KDS Textile Mills Ltd

251-252, Nasirabad I/A, Baizid Bostami Road, Chattogram, Bangladesh
(22.392529, 91.819859)
15 September 2022

Buildings Information

Damaged Column

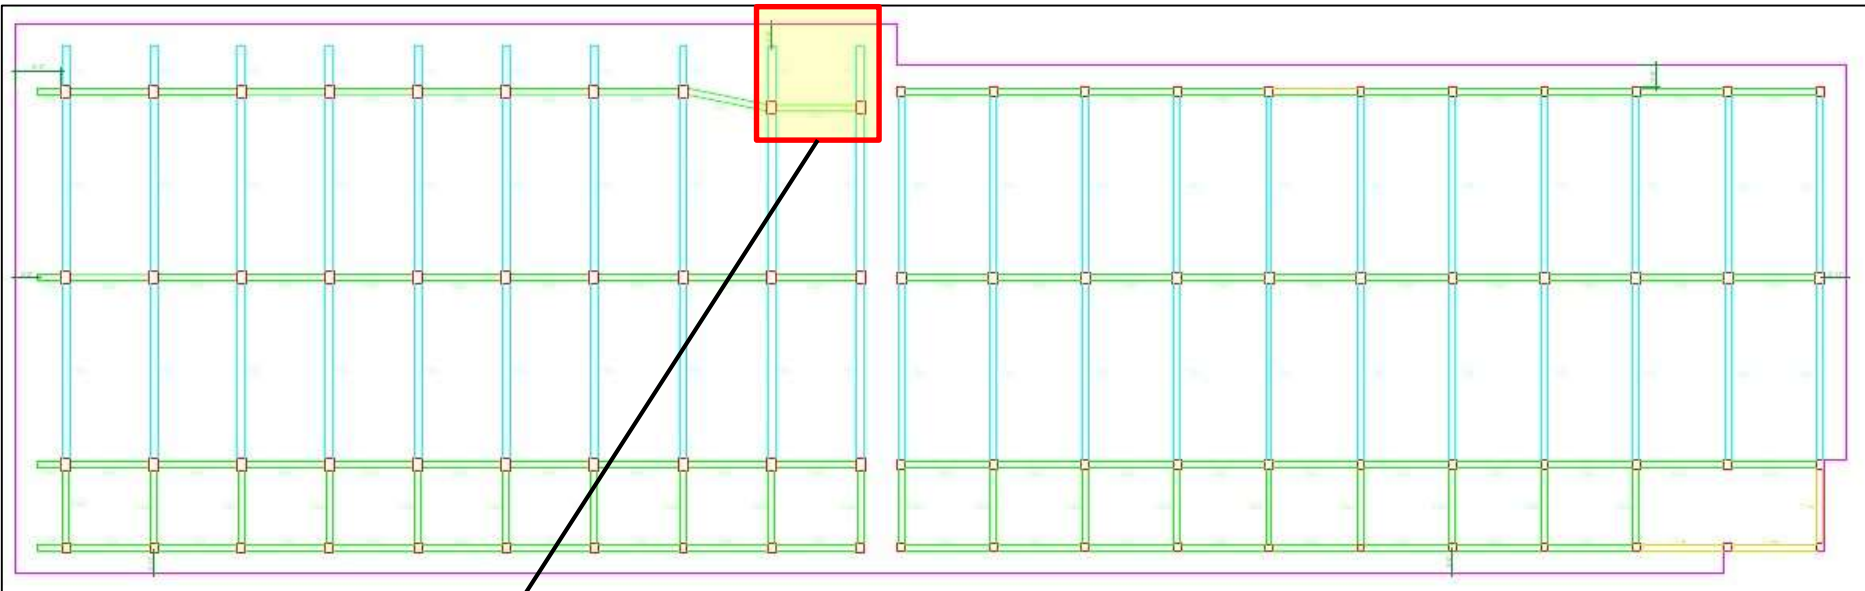
Damaged column was found on the south-west corner of the ground floor at the stair area (Marked in Figure-1) of the 7-storied factory Building (Block-B).

The factory must immediately engage a consultant to investigate the damaged column. Any safety measures, if required as suggested by the consultant must be taken immediately to ensure safety.

Vertical bracing (I-section)

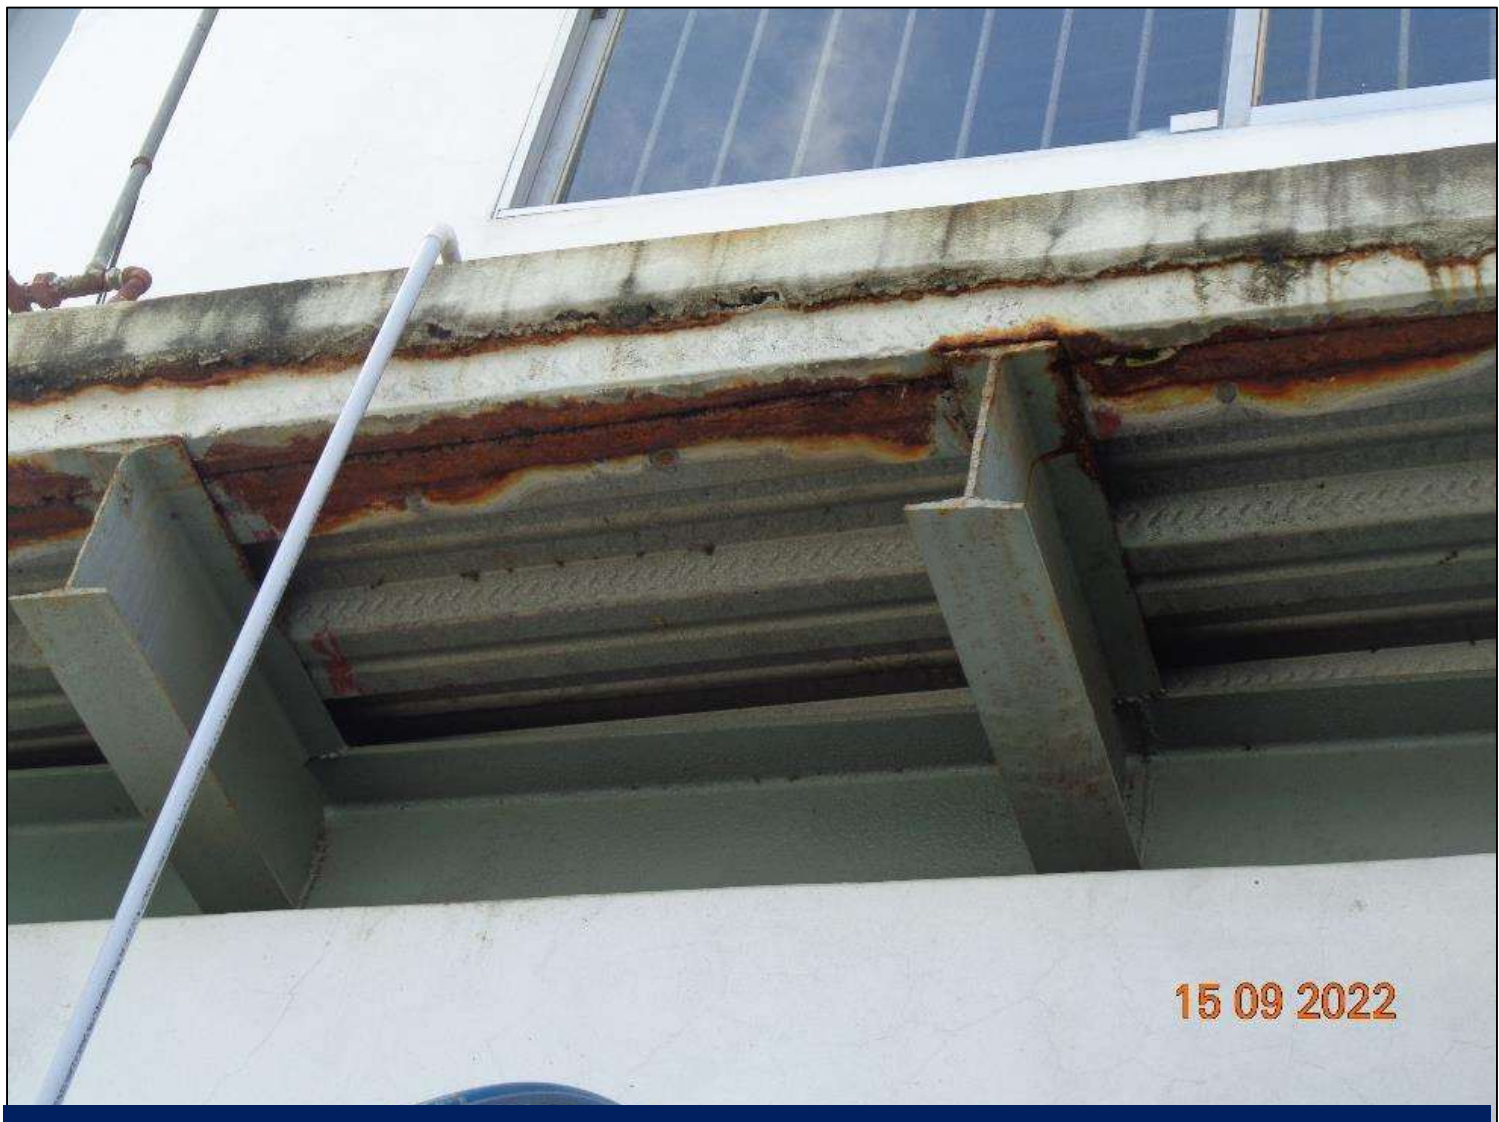
No information related to vertical bracing details in the as built drawing of Block-C (Steel Part).

SCHEDULE OF MAIN BEAM

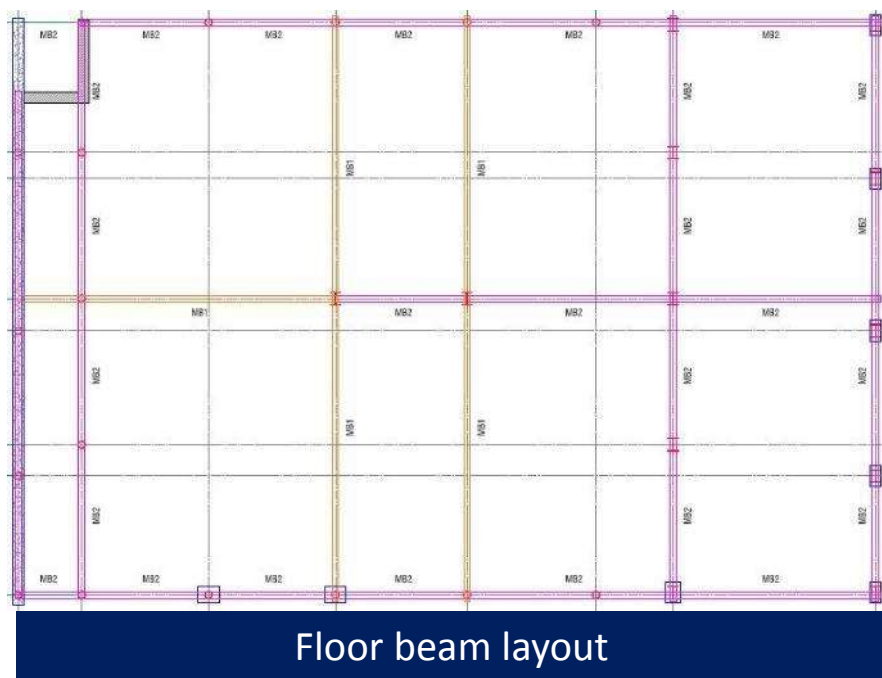
During inspection all MB2 floor beam size found W-300(6)mm X 100(8)mm instead of W-300(6)mm X 150(8)mm. The building is required to survey the structure and prepare accurate as-built drawings.

Onsite bracing condition

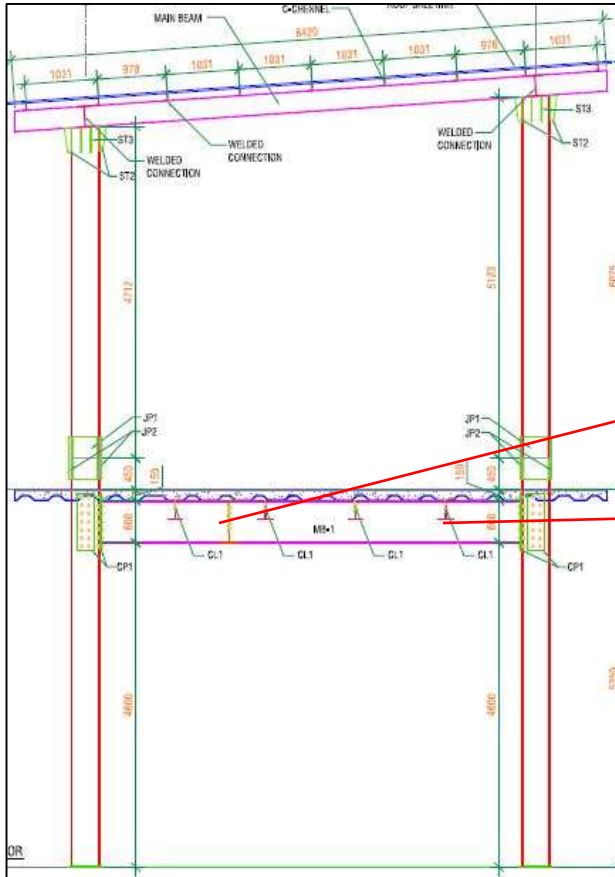
During inspection, no cable bracing was found at any floor, but in as built drawing 16mm cable bracing has been shown.
